Access Compliance Report

Public Rights-of-Way

Intersection ID: N/A	Main Street: NORTHLAKE CENTRE PY	Cross Street: N/A	Location: SW
ADA ID: ED0EA9F09391	Ramp Type: PerpDiag	Initial Pass/Fail: Fail	Overall Compliance: No
		Severity Score: 25

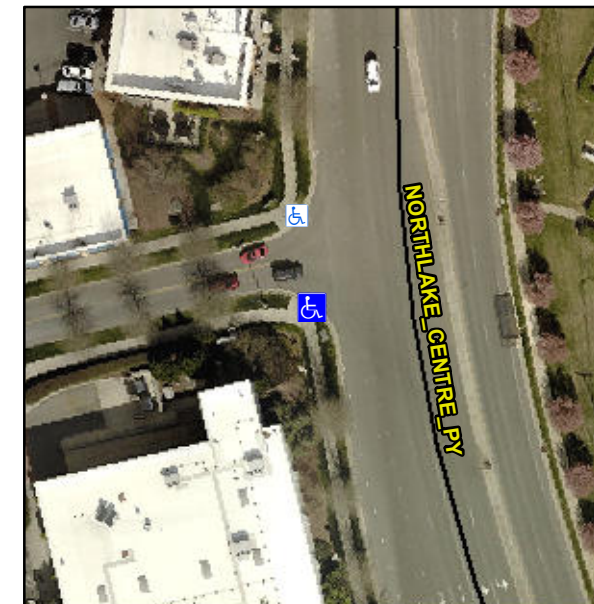
Not Found, R304.5.3

Compliance	Description	Data	Compliance	Description	Data
N/A	Ramp Length (in)	43.0	Yes	Ramp Slope (%)	5.4
Yes	Ramp Width (in)	59.0	No	Ramp XSlope (%)	7.3
N/A	Flare Type LT	N/A	N/A	Flare Type RT	N/A
N/A	Flare Slope LT (%)	N/A	N/A	Flare Slope RT (%)	N/A
N/A	Flare Traversable LT?	No	N/A	Flare Traversable RT?	No
N/A	Landing Length (in)	N/A	N/A	DWS Provided?	N/A
N/A	Landing Width (in)	N/A	N/A	DWS Contrast?	N/A
N/A	Landing Slope (%)	N/A	N/A	DWS Length (in)	N/A
N/A	Landing X Slope (%)	N/A	N/A	DWS Full Width?	N/A
N/A	Landing Curb? (Y/N)	N/A	N/A	DWS Offset (in)	N/A
N/A	Shared Landing?	N/A			
N/A	Gutter Ponding?	N/A	N/A	Gutter Slope (%)	N/A
N/A	Gutter Lip Ht (in)	N/A	N/A	Gutter X Slope (%)	N/A
N/A	Painted X Walk1?	No	N/A	Painted X Walk2?	No
	X Walk 1 Direction	To E		X Walk 2 Direction	To N
N/A	X Walk 1 Width (in)	N/A	N/A	X Walk 2 Width (in)	N/A
	X Walk 1 Slope (%)	3.2		X Walk 2 Slope (%)	3.5
	X Walk 1 X Slope (%)	4.7		X Walk 2 X Slope (%)	2.4

Remove & Replace Curb Ramp With Two New Directional Ramps or Equivalent.
